BANK FARM, HIGHER LANES, WHITCHURCH, SY13 3AX

Alternative Scheme comprising:

Planning Application: P/2023/0360; and

Listed Building Consent Application: P/2023/0359

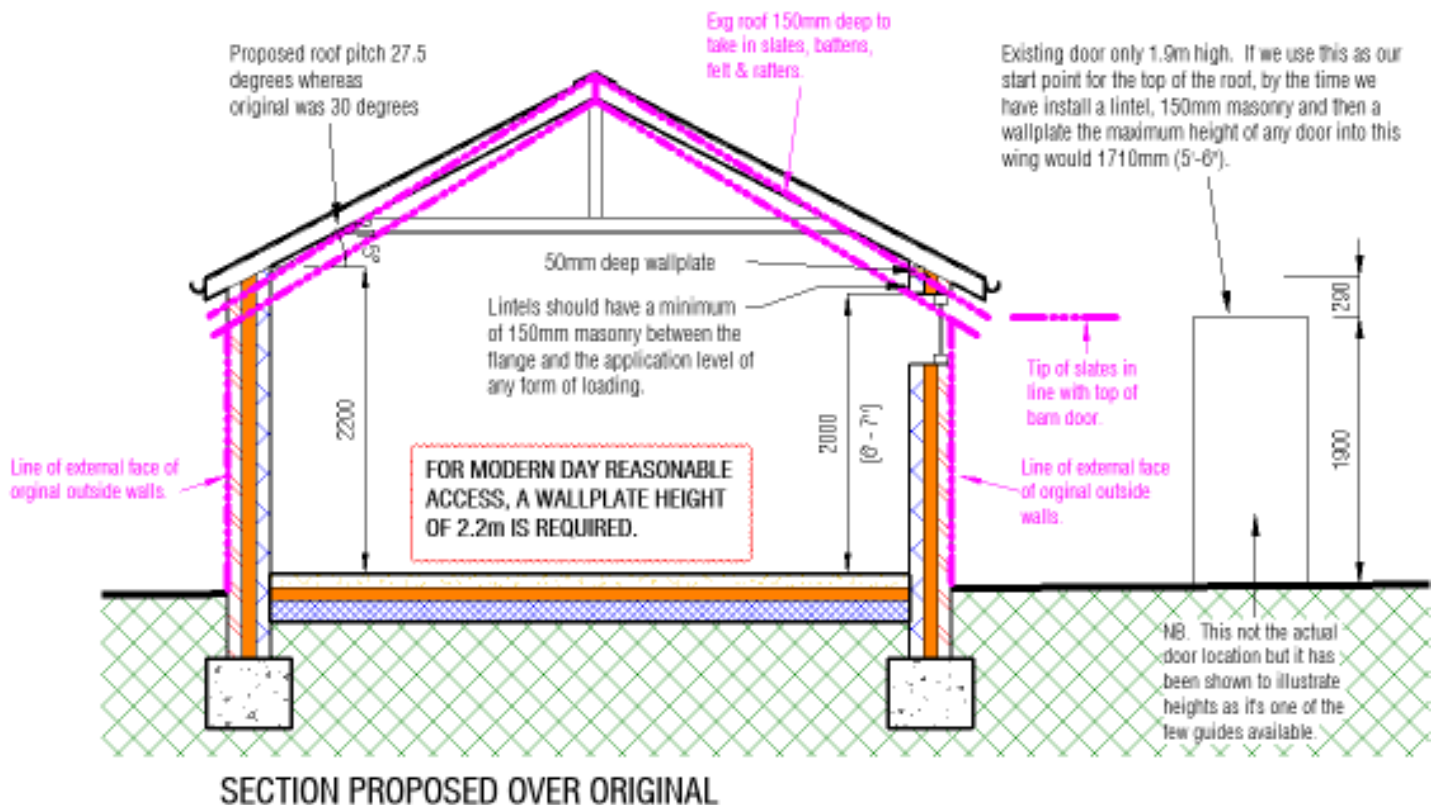
- **Roof - Use 4x2" C 16 timber rafters at 450mm centres with pitch to match the existing Shippon. The roof profile and ridgeline to be as the outline on the Shippon wall. 2no. braced king-post timber trusses are to be formed using 8x4" primary rafters, the king-post and bottom chord with 4x4" braces and 8x4" timber purlins at approximately mid-span of each pitch. Trusses are to be located between windows, but at approximately third-points between the Shippon wall and the internal Milking Parlour wall. 2x1" battens and roof slates are to match the original rear extension. Seal between outbuilding roof and Shippon wall using lime mortar haunching**

- As agreed with the Conservation Officer, the Alternative Scheme provides for a roof height which replicates the original, with a roof profile which differs very slightly from the original alignment in order to achieve a useable internal height within the building, see detail below

- The specification for the roof will need to comply with building regulations, to this end calculations justifying the design will need submitting to building control in course to justify the size of timber members to be used. Indicative details for the king post trusses are given on Drawing 22-141b rev e
- Lime mortar will be used where required and will be regulated as part of the pointing condition in any event.
